Kennecott Uranium Company
Sweetwater Uranium Project
Post Office Box 1500
Rawlins, Wyoming 82301-1500
Phone: (307) 328-1476
Fax: (307) 324-4925

Subject: Sweetwater Uranium Project – Docket Number 40-8584
Source Material License #SUA-1350 – Response to Comments:

- **License Renewal Request**
- **License Amendment for the Proposed Change to the Groundwater Corrective Action Program, Environmental Monitoring Program and Reclamation Plan**

**RESPONSE TO COMMENTS
RE: License Amendment
Request – May 12, 2004**

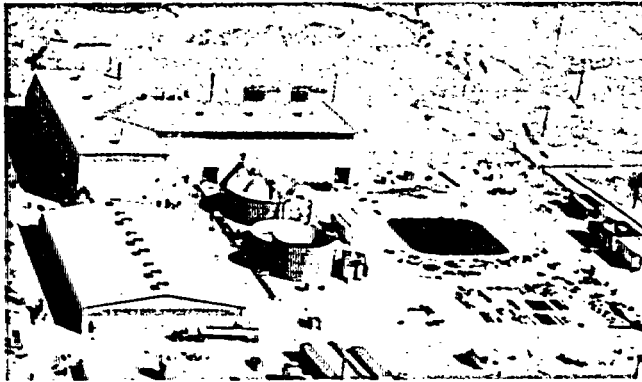
Methyl ethyl ketone has been detected in small quantities in some samples in the following well(s): TMW-91, TMW-92, TMW-102 and TMW-105. Methyl ethyl ketone is a major ingredient in primer and glue used to connect PVC pipe. The methyl ethyl ketone discovered in the above listed wells is believed not to be derived from the aquifer but rather from pipe fitting materials. In TMW-91, methyl ethyl ketone concentrations have dropped from 9.8 milligrams per liter to non-detect. This well was completed using primer and glue (as opposed to threaded pipe and screen) and the rapid drop in concentration indicates that this contaminant is not in the Battle Spring Aquifer, but rather is derived from the casing. In TMW-92, methyl ethyl ketone was detected in the initial sample and has been non-detect in all subsequent samples. TMW-102 exhibits low levels (24 to 41 micrograms per liter) with the June 15, 2004 sample being non-detect. TMW-105 (which is not a Battle Spring Aquifer well, but a perched fluid recovery well) exhibited methyl ethyl ketone in two samples; 250 micrograms per liter on March 23, 2004 and 25 micrograms per liter on June 15, 2004. The concentrations have declined by an order of magnitude and are believed to be related to the piping.

The high concentrations of methyl ethyl ketone in PVC glue and primer are clearly shown in the analysis results for PVC primer and cement provided in Appendix 5. PVC primer contains 543,000 milligrams per kilogram (54.3%) methyl ethyl ketone and PVC cement contains 150,000 milligrams per kilogram (15%) methyl ethyl ketone.

Thus, since it is not believed to be a groundwater contaminant, methyl ethyl ketone was not listed in the original amendment request and no ground water standard is proposed for it. Testing will continue for methyl ethyl ketone since it is included in the normal suite of volatile organic chemicals. Should it appear that piping materials are not the source and that it is derived from the aquifer, a groundwater protection standard will be proposed.

Catchment Basin Aerial Photographs

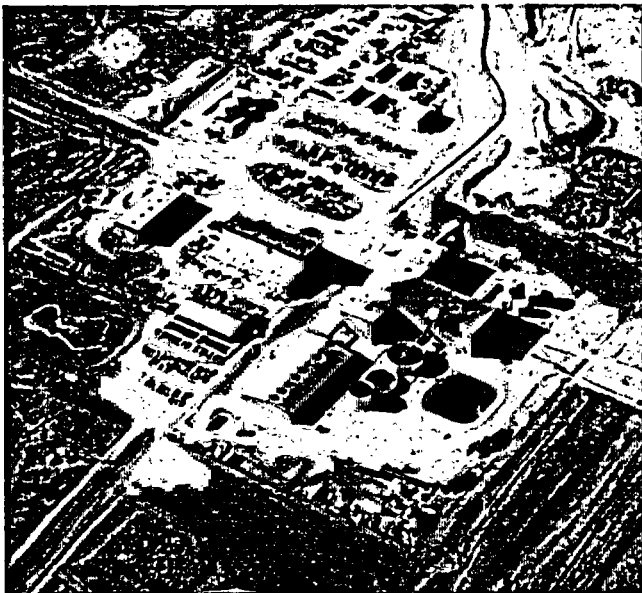
2. Reasons for Testing in the Catchment Basin Area

The mill has not operated since April 15, 1983. Aerial photographs dated September 25, 1980 (pre-operational), September 28, 1981, March 25, 1982 and July 26, 1982 all showed the Catchment Basin filled with fluid. The September 29, 1981 and March 25, 1982 photographs showed the basin filled with brown fluid. Based on the knowledge that the basin lacked a concrete bottom and the knowledge that it was filled in four aerial photographs taken over three years, an investigation was undertaken. These photographs are included on page 5 of this *Response to Comments*.

**Appendix 3
Catchment Basin – Battle Spring
Aquifer Hydrocarbon
Contamination Map**

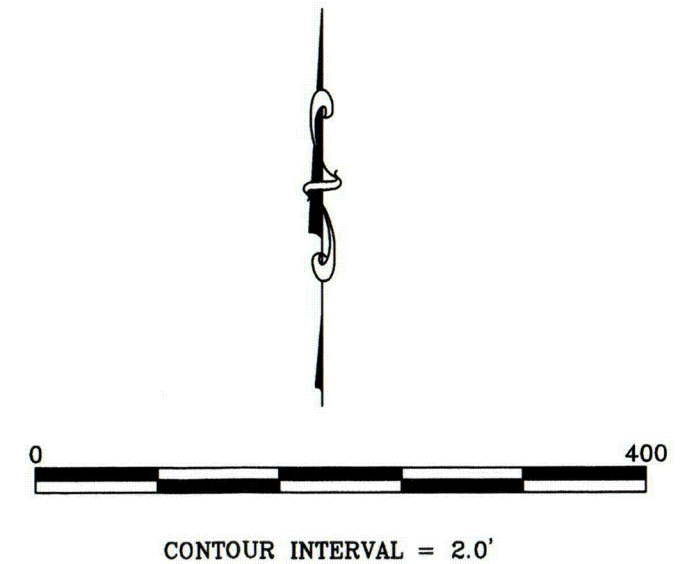
4. Organic Groundwater Plume Map

The requested organic plume map is included in Appendix 3 of this submittal, entitled "Catchment Basin – Battle Spring Aquifer Hydrocarbon Contamination Map". In addition to the wells recently completed around the Catchment Basin, the two potable water wells (PWW-1 and PWW-2) north of the Catchment Basin were sampled and found to be free of any organics. Sample data for these wells is included with this submittal in Appendix 4. TMW-52, an existing tailings impoundment monitor well, was also sampled for organics in September, October and November of 2003. The September 15, 2003 sample contained 3.8 micrograms per liter naphthalene. Subsequent samples were free of organics.
